# SCHWEIZER SERVICE BULLETIN

B-277  
25 Jan 2002

SUBJECT: ONE-TIME INSPECTION OF CERTAIN 269A2234-3 (LH) AND 269A2235-3 (RH) AFT CLUSTER FITTINGS

Figure B-277-1. Inspection of Cluster Fittings

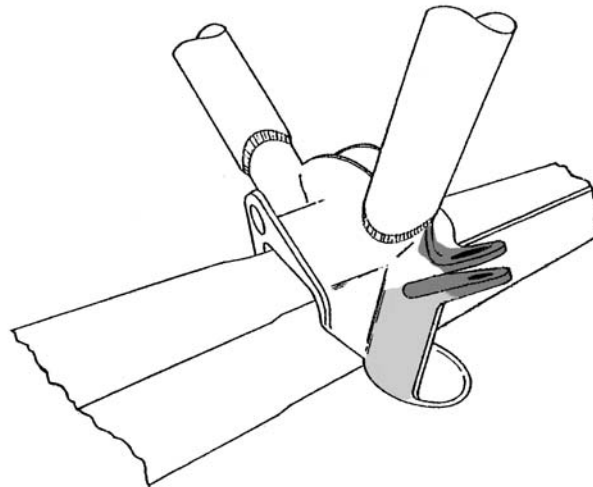
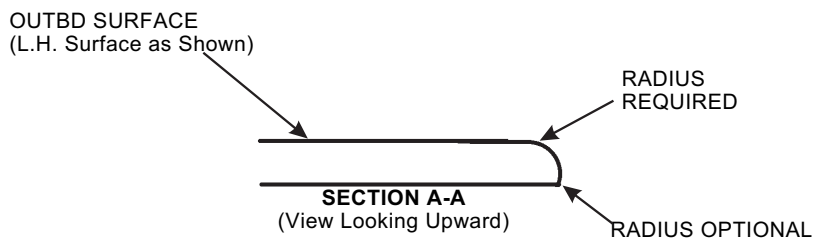
- c. If no cracks are found, perform at least a 5X visual inspection on attachment lugs (Figure B-277-1). Inspect lugs and vertical webs above and below lugs for nicks, scratches, gouges, and other surface defects.

- d. If surface defects are found on lugs, use progressively finer grades of abrasive material to remove defects up to the maximum repairable limits specified in Figure B-277-1. Remove material only as necessary to remove defects. Polish lugs smooth with 320 grade (or finer) abrasive paper.

- e. Measure thickness of lugs; it must be a minimum of 0.115 inch after rework. If lug thickness is less than 0.115 inch, replace cluster fitting (Paragraph 13-44).

INSPECTION AREA	TYPE OF INSPECTION	MAXIMUM SERVICEABLE LIMITS	MAXIMUM REPAIRABLE LIMITS
	VISUAL W/10X MAGNIFYING GLASS	NO IMPERFECTIONS ALLOWED	REFER TO FIGURE B-277-2
	DYE PENETRANT AND VISUAL	NO IMPERFECTIONS ALLOWED	LUG MUST BE MIN. OF 0.115 INCH THICK AFTER REWORK

Figure B-277-2. Radius Limitations

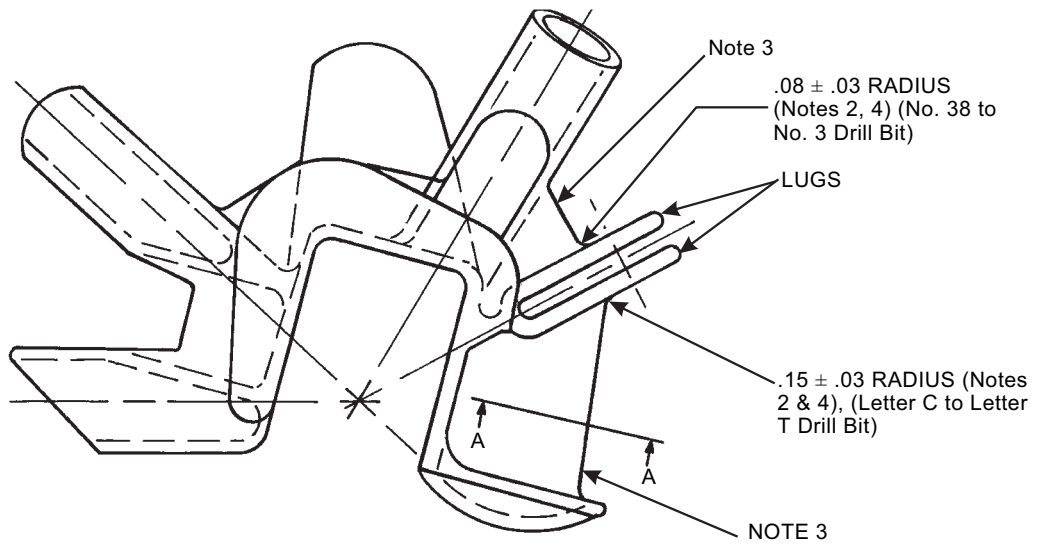
- f. Using a radius gage or suitable drill size, check for correct fillet radii in web between attachment lugs (as shown in Figure B-277-2).
- g. If radii is not correct, use appropriate size round file and progressively finer grades of abrasive paper to feather radii into web (as shown in Figure B-277-3). Remove no more material than necessary; polish smooth with 320 grade (or finer) abrasive paper. Do not feather radii into lug. (Undercuts are not permitted.)

- h. Visually inspect vertical webs above and below lugs for a radius at outer edge of webs (Section A-A). If necessary, use grade 220 (or finer) abrasive paper to obtain a smooth rounded edge.

1. ALL DIMENSIONS IN INCHES.
2. NO UNDERCUTS PERMITTED. SMOOTHLY TRANSITION RADII INTO WEB AND BLEND TO MATCH CONTOUR (see Figure B-277-3). USE RADIUS GAGE OR SUITABLE DRILL BIT SIZE TO MEASURE RADIUS.
3. RADIUS REQUIRED ALONG ENTIRE OUTBOARD EDGE OF WEBS.
4. IF REWORK OF RADIUS IS PERFORMED, DO NOT UNDERCUT INTO LUGS.
